BUSHFIRE ASSESSMENT REPORT

FOR PROPOSED SUBDIVISION OF

Lot 6 DP 1128635

11 Westminster Place

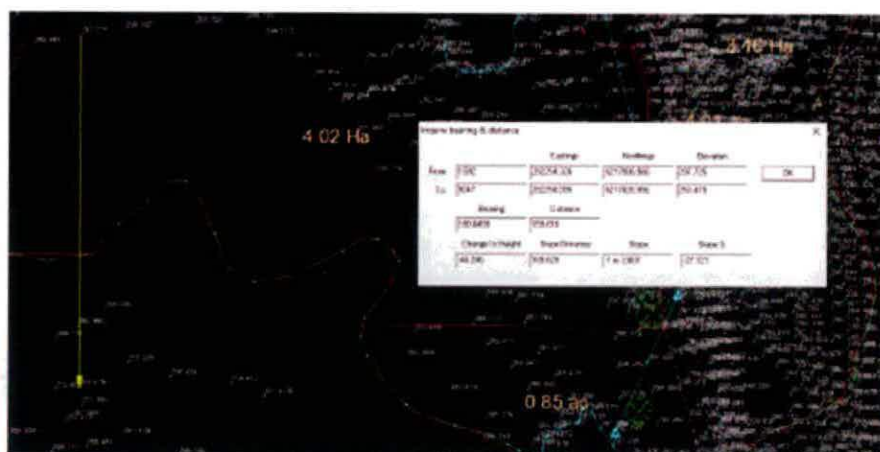
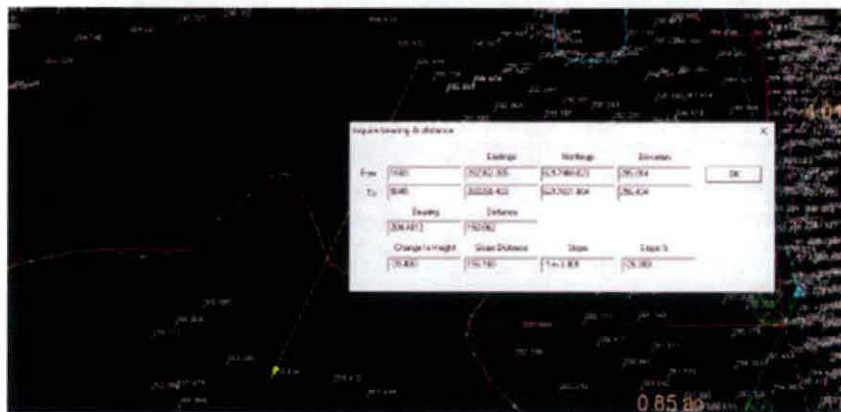
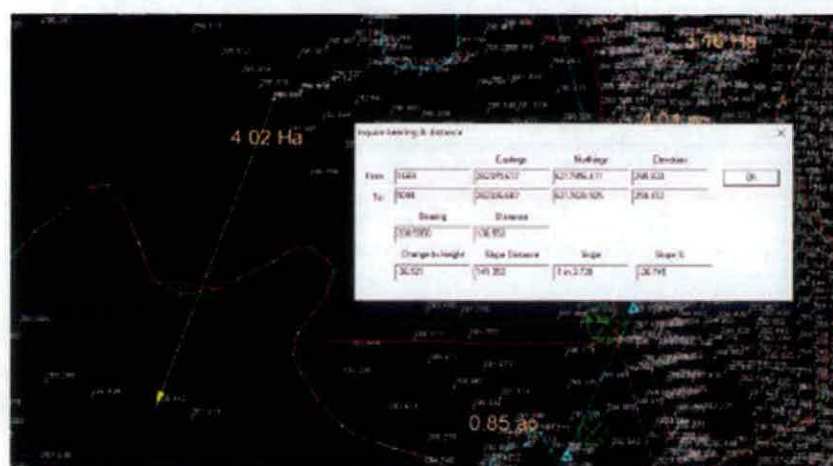
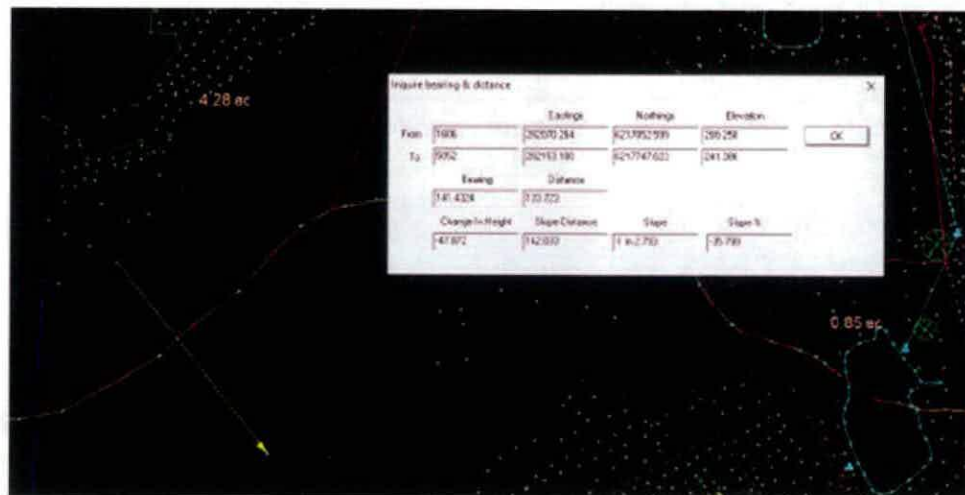
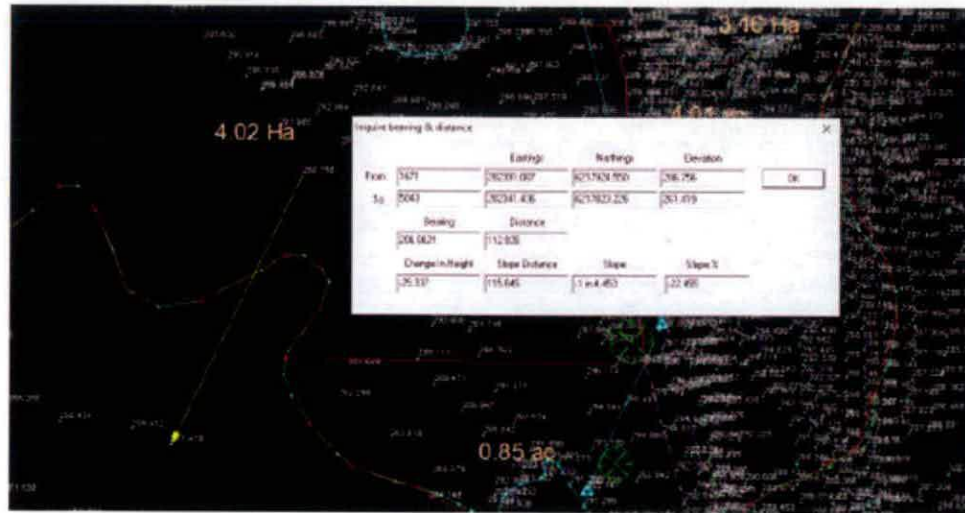
- I. As noted in the bushfire assessment report, slopes identified were established from survey of the subject land – a copy of the survey plan was already included in the report. Please contact the author should a PDF version be required.
- II. The survey of the subject land was undertaken by Paul Brandon of Australian Survey Solutions. In addition to being a registered surveyor, Paul is also an accredited BPAD consultant and thus is very familiar with the importance of accurate slopes in bushfire areas.
- III. Further, Paul Brandon has confirmed that regarding the natural surface level shots obtained to ascertain the slope:

- VI. Screenshots of the survey data bearings and distances used to identify the slopes have been included after this letter.
- (d) Plan showing APZ for each lot

19.69° – this is further west and not in line to any building envelope

Amended Plans submitted Aug 2016

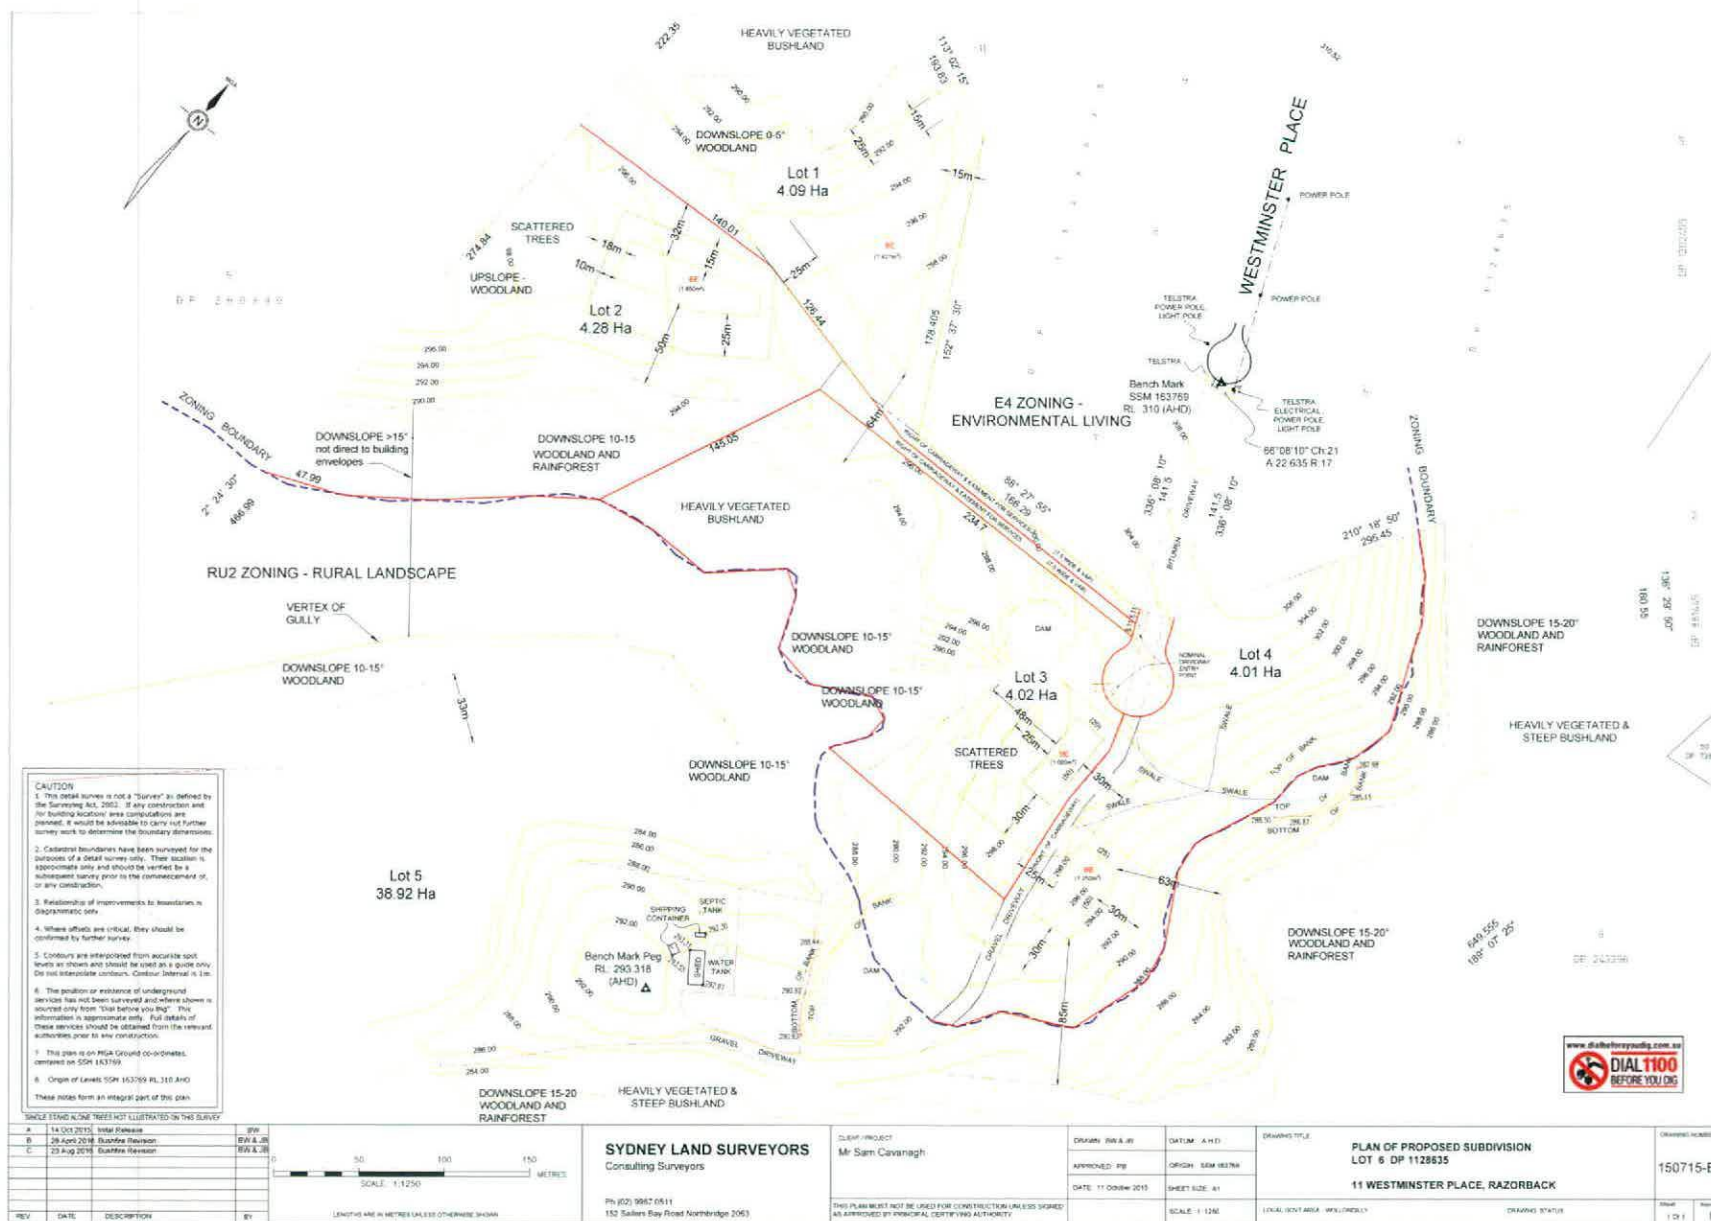
I refer to your letter dated 8 August 2016 in response to an integrated development application for the above property, and a request for additional information by the NSW Rural Fire Service (RFS), to aid in determination of the application.

- I. See attached plan identifying APZ's for each building envelope
- II. Building envelope of proposed lot 1 has been amended, with the southern edge of the building envelope being moved north of the proposed lot boundary to ensure the 25m APZ as per Table A2.4 *Planning for Bushfire Protection 2006* is wholly contained within the lot. This changes the BAL for this elevation to BAL 12.5
- III. 88B instrument as indicated in (a)II above would ensure grazed land would remain clear access and non-hazardous

- IV. The slope at the most western edge of the subject land is $>15^\circ$ downslope into this gully. However, this slope is *not* in the direction of any of the building envelopes – see the new plan for where this slope is located and the direction of this slope.

- I. See attached plan identifying APZ's for each building envelope – as per Table A2.4 PBP 2006
